# Rezoning Application: RZ-PD 25-0932

Zoning Hearing Master Date: November 17, 2025

## 1.0 APPLICATION SUMMARY

The applicant is requesting to rezone the 10.69-acre property zoned AR to Planned Development (PD) to allow for two planning options. Option 1 would allow for 53 single family units and accessory Storage for Operable Recreational Vehicles and Operable Private Pleasure Crafts and Operable Utility Trailers for the residents. Option 2 would allow Recreational Vehicles and Private Pleasure Crafts and Utility Trailers Storage & an Art Studio.

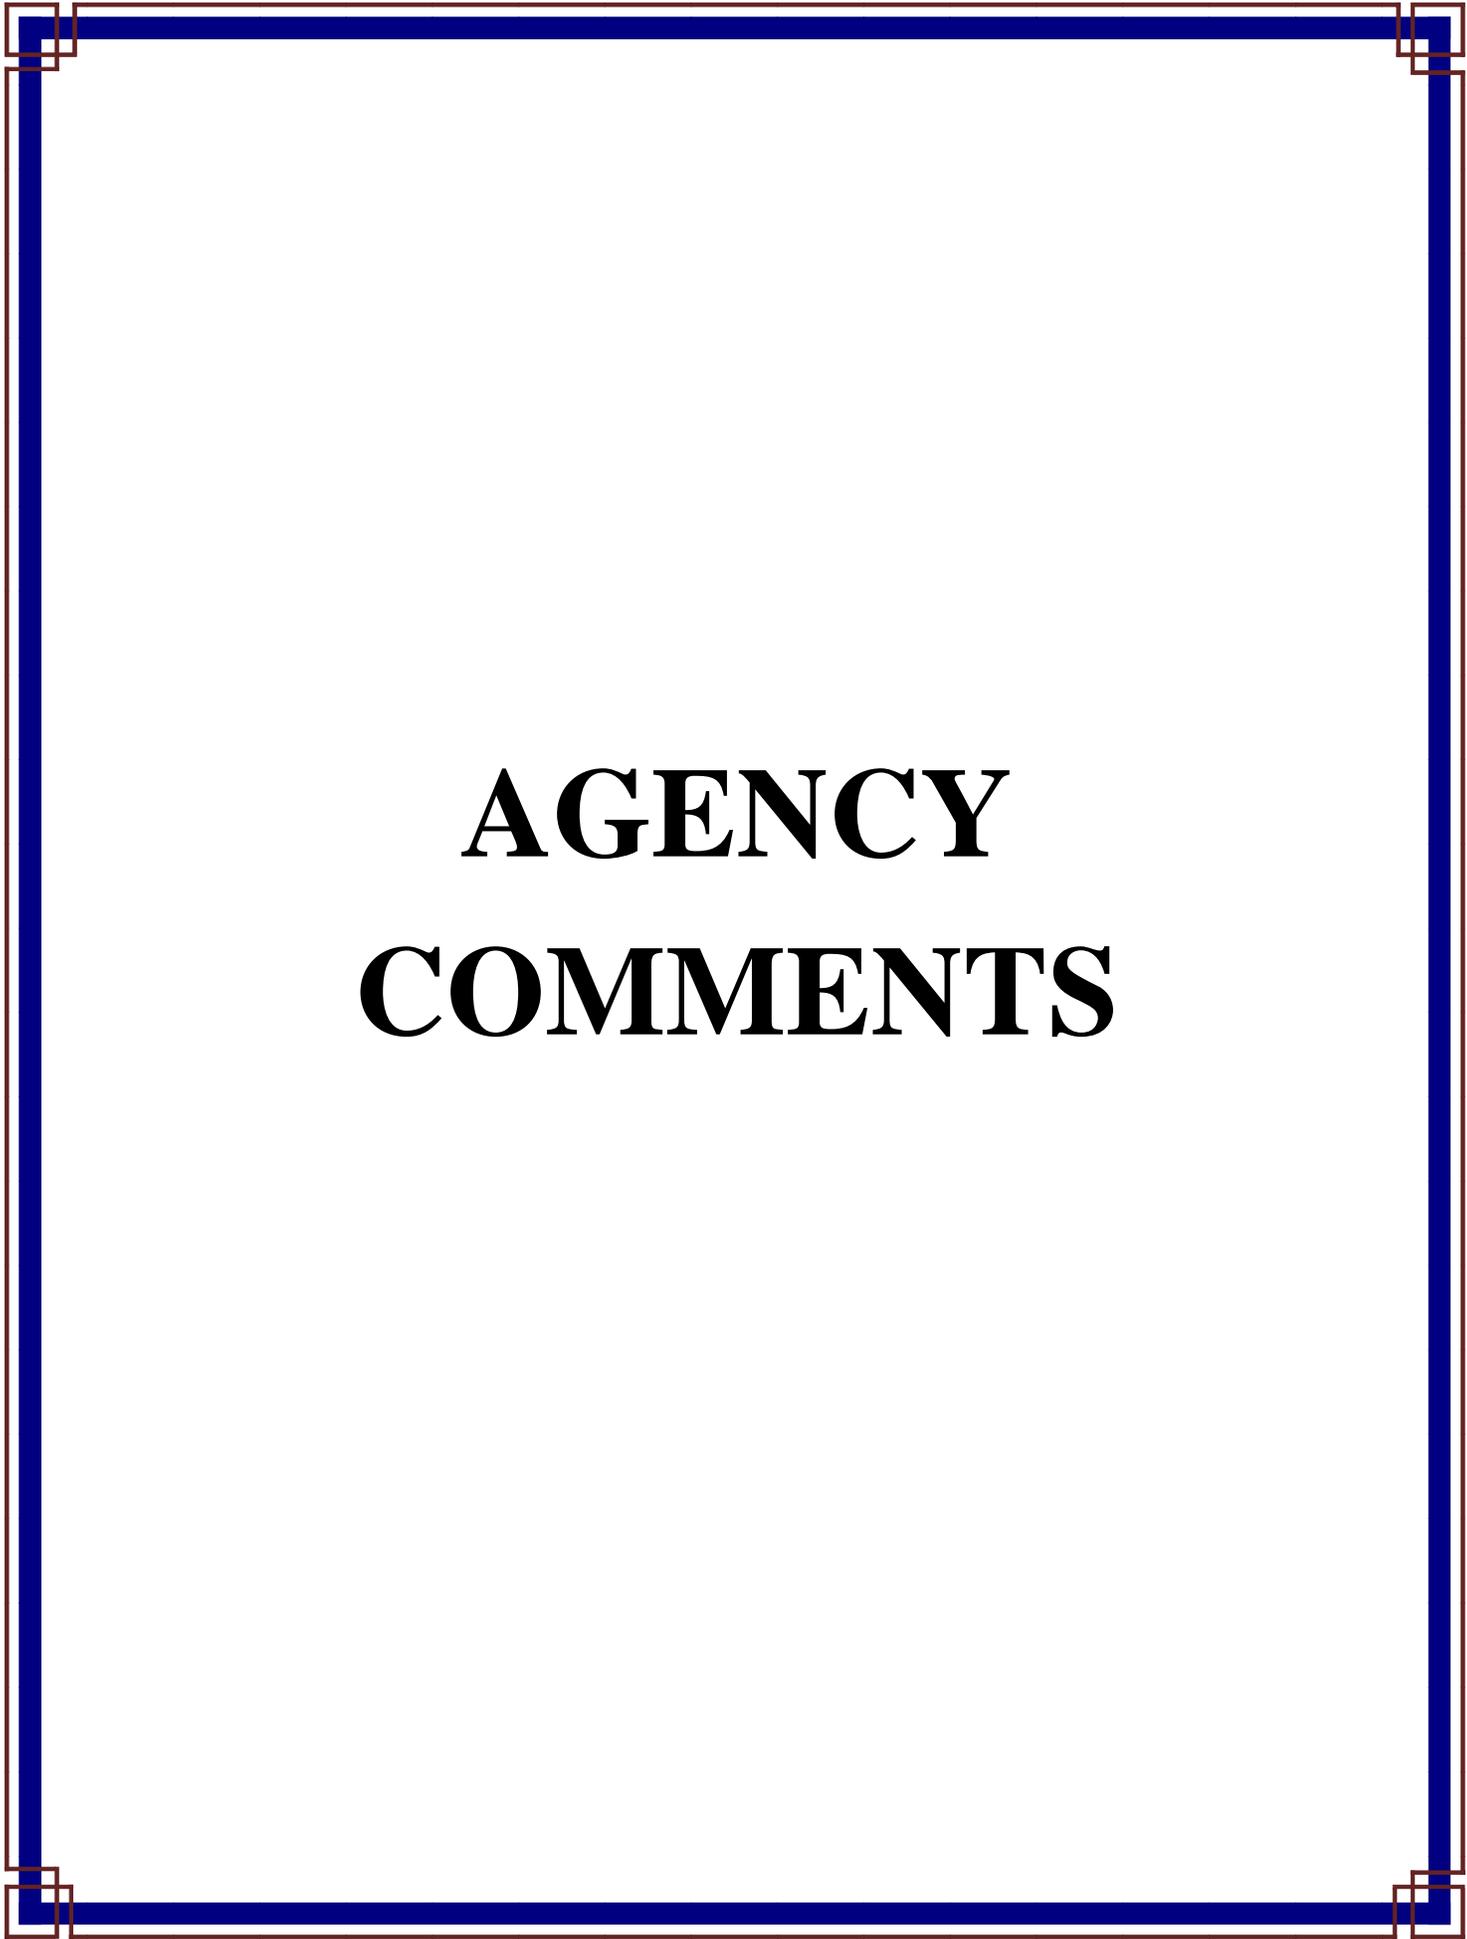
- On PD Site Plan Sheet 2 of 2:
  - Within the “Proposed Use” column of the “Uses Table”, revise the language stating “OPTION 2: RECREATIONAL VEHICLES AND PRIVATE PLEASURE CRAFTS AND UTILITY TRAILERS STORAGE & ART STUDIO (CN USE)” to instead state “OPTION 2: RECREATIONAL VEHICLES AND PRIVATE PLEASURE CRAFTS AND UTILITY TRAILERS STORAGE & ART STUDIO”.
